BULLETIN

NUMBER 116

SUBJECT: Battery Box Lid

MODELS AFFECTED: Piper Model PA-20 Serial Numbers 20-553 thru 20-600 incl., 20-602 thru 20-623 incl., 20-627 thru 20-631 incl., 20-633 thru 20-641 incl., 20-643 thru 20-649 incl., 20-651, 20-654, 20-656, 20-660 and 20-662, also, Model PA-22 Serial Numbers 22-1 thru 22-33 incl., 22-35 thru 22-37 incl., 22-43, 22-51, 22-53 and 22-54.

SKETCH #2

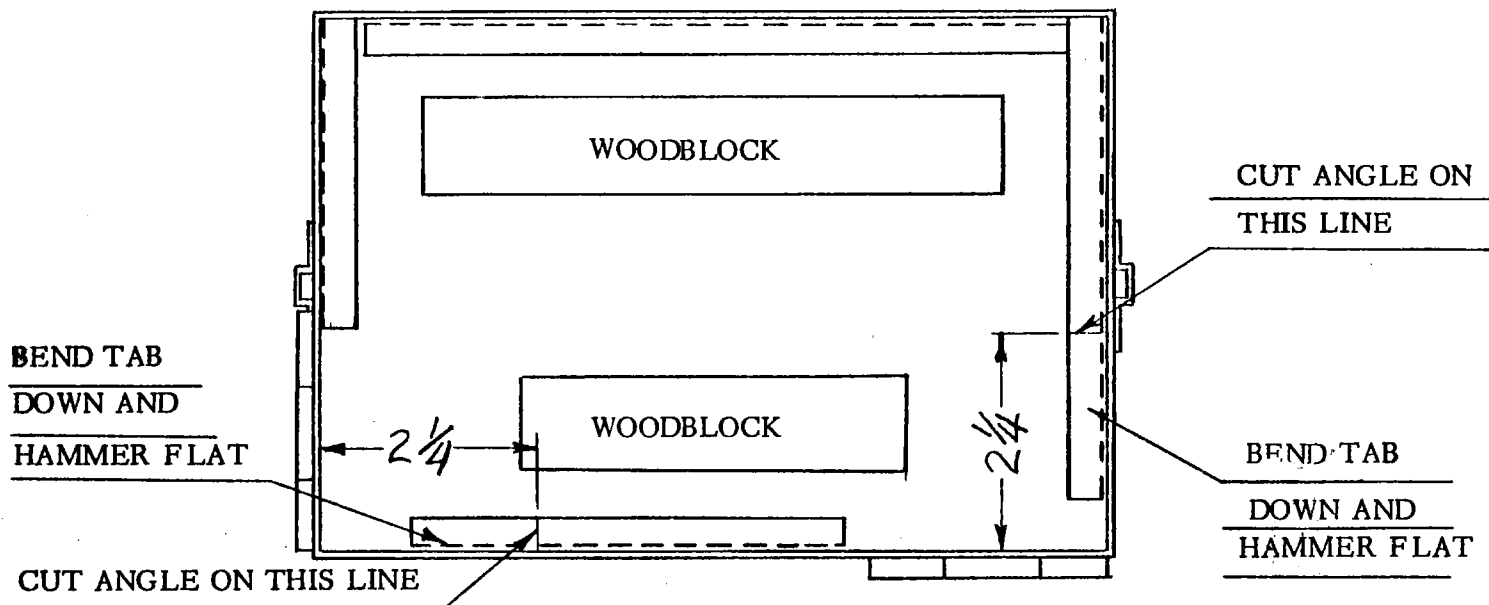
Lids of the type construction shown in Sketch No. 2 must be reworked as indicated.

FOUR ANGLES SPOTWELD TO INSIDE OF LID
